ADDENDUM #1**1.1 PROJECT INFORMATION**

- A. Project Number: 2026-11230
- B. Project Title: BEB On-Route Charging Infrastructure
- C. Project Location: STA's Valley Transit Center at 10501 E 4th Ave, Spokane Valley, WA & Liberty Lake Park & Ride at 22501 E Mission Ave, Liberty Lake, WA
- D. Agency: Spokane Transit Authority

STA Route 9 BEB Charging Addendum #1 Narrative

SYMBOLS LIST, ABBREVIATIONS, AND GENERAL NOTES

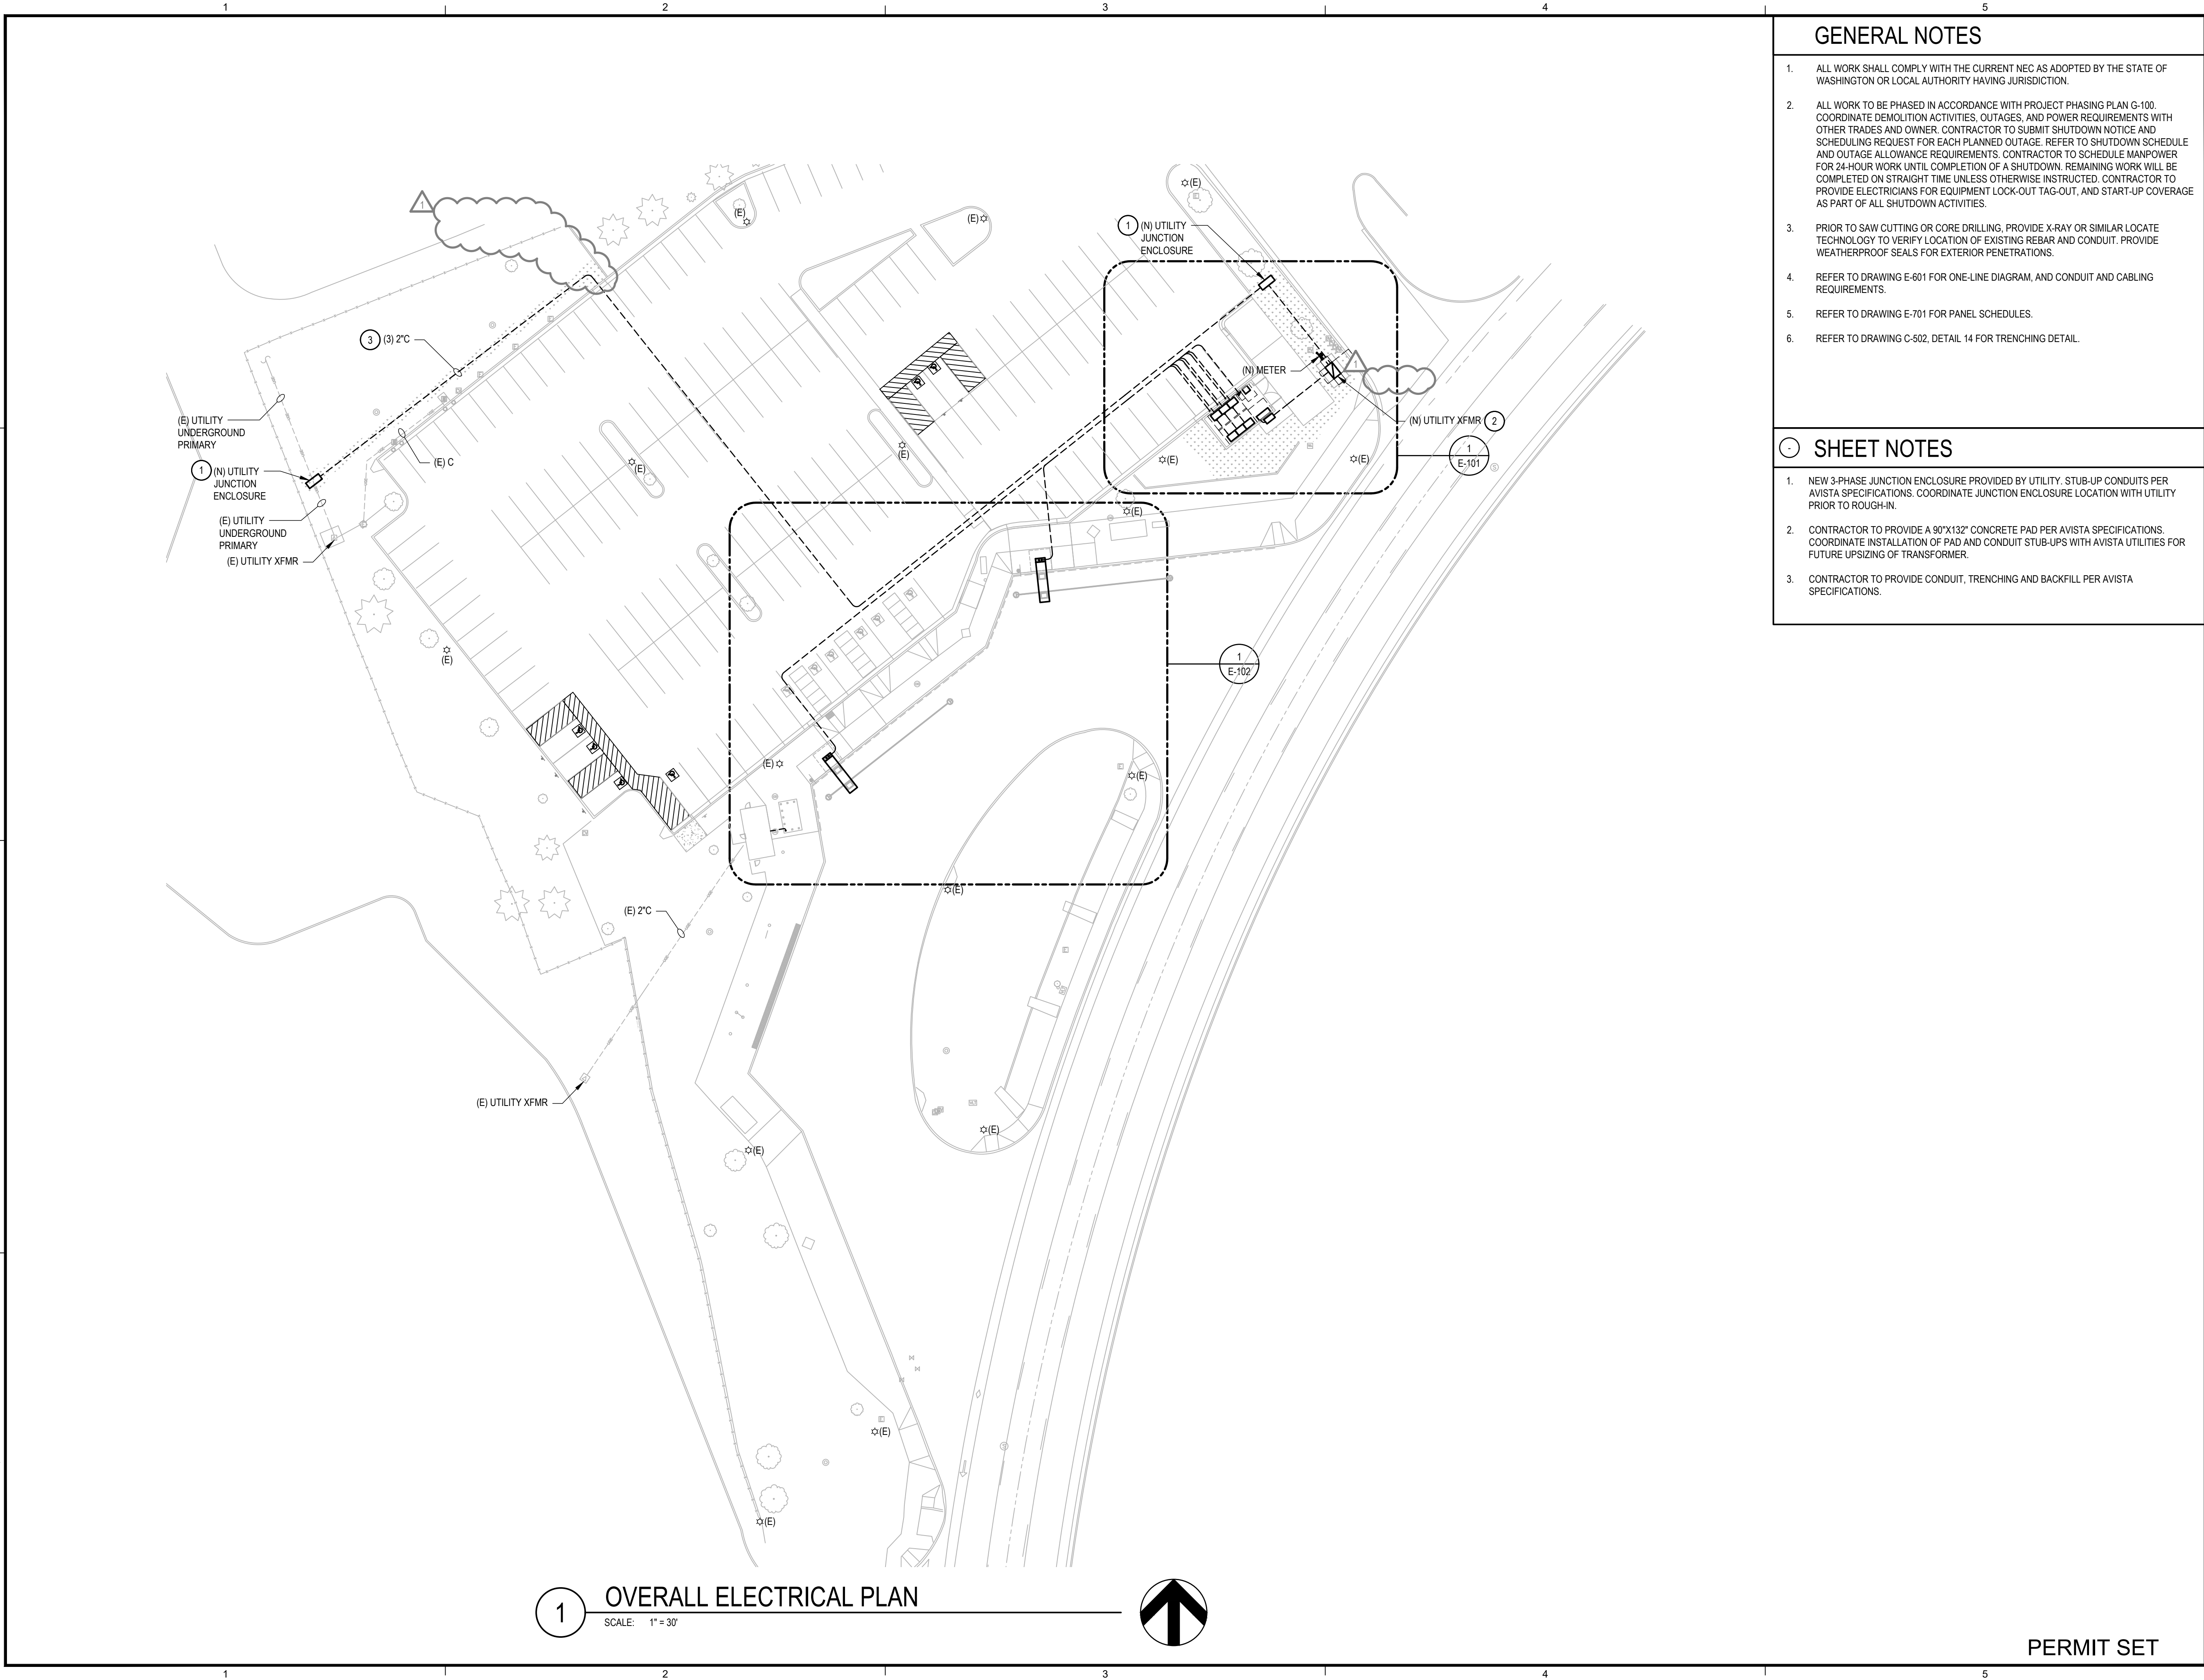
C. SHEET E-001 – SYMBOLS LIST, ABBREVIATIONS, AND GENERAL NOTES

1. Revised: General notes 9 and 10. Owner to pay utility application, connection, and inspections fees per specifications.
- D. SHEET E-100 – OVERALL ELECTRICAL PLAN

OVERALL ELECTRICAL PLAN

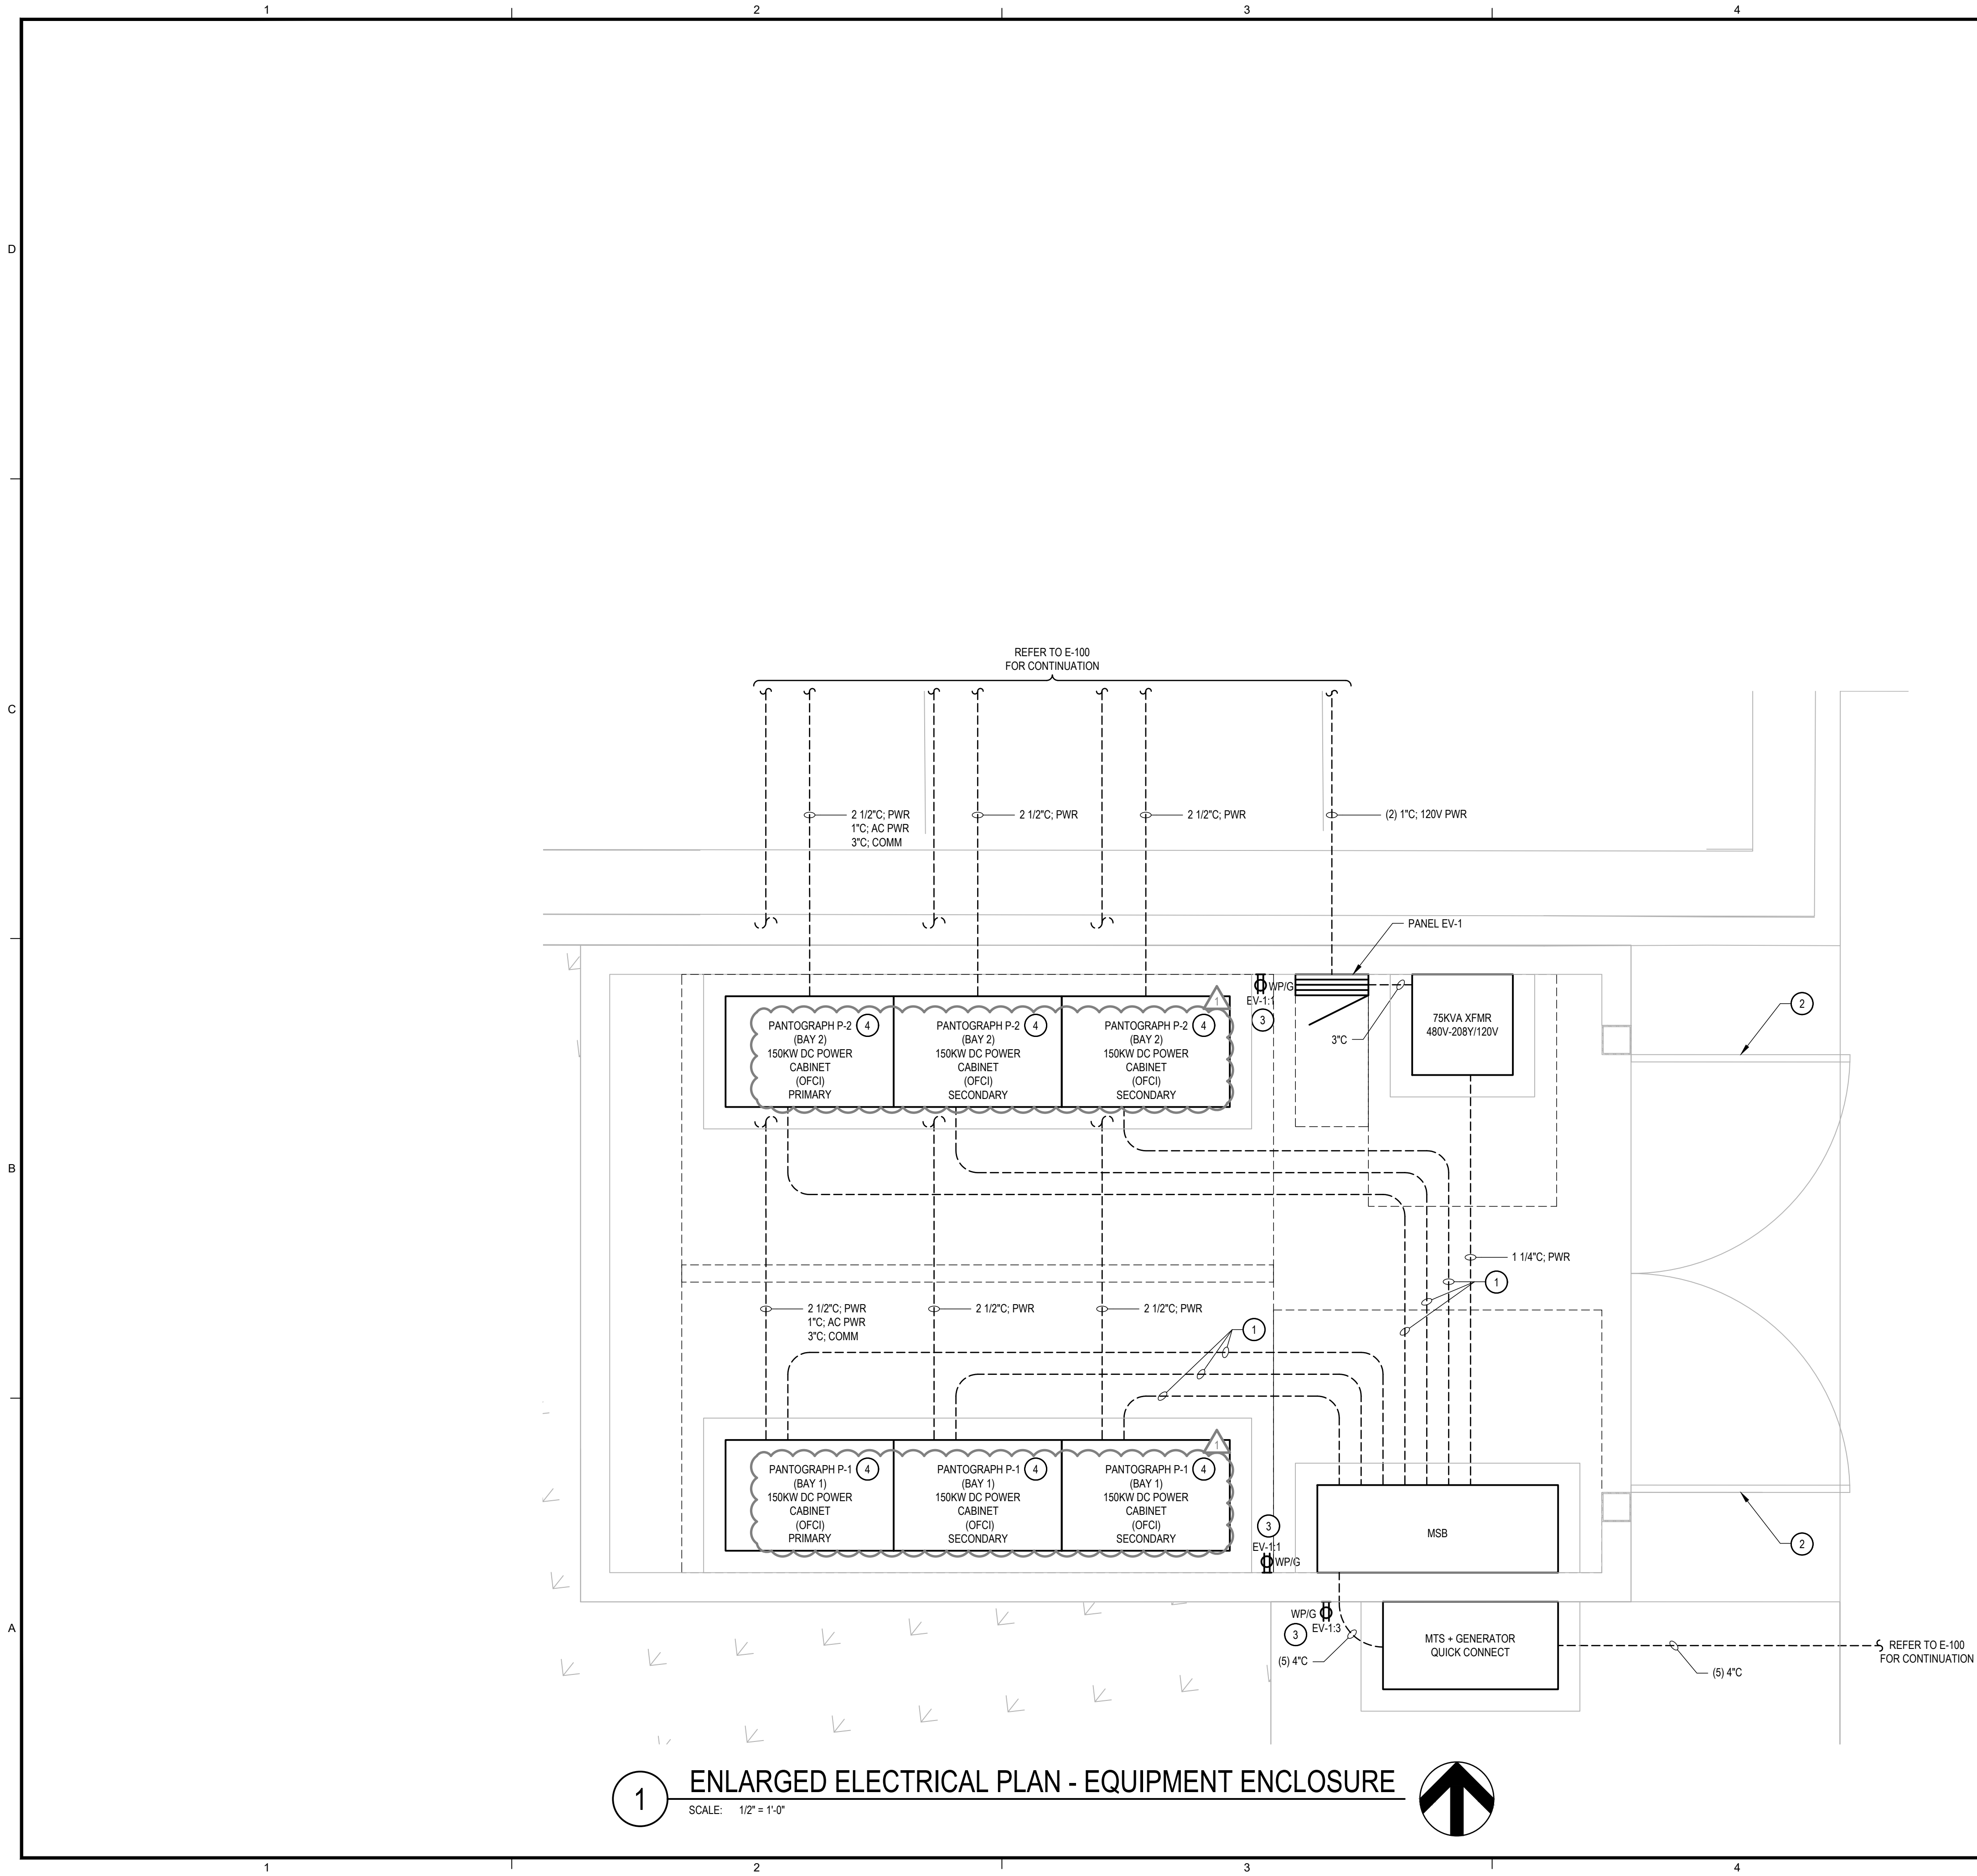
1. Removed: Utility junction enclosure per Avista plan review comments.
- E. SHEET E-401 – ENLARGED ELECTRICAL PLAN - EQUIPMENT ENCLOSURE
 1. Revised: Callout for locking receptacle covers.
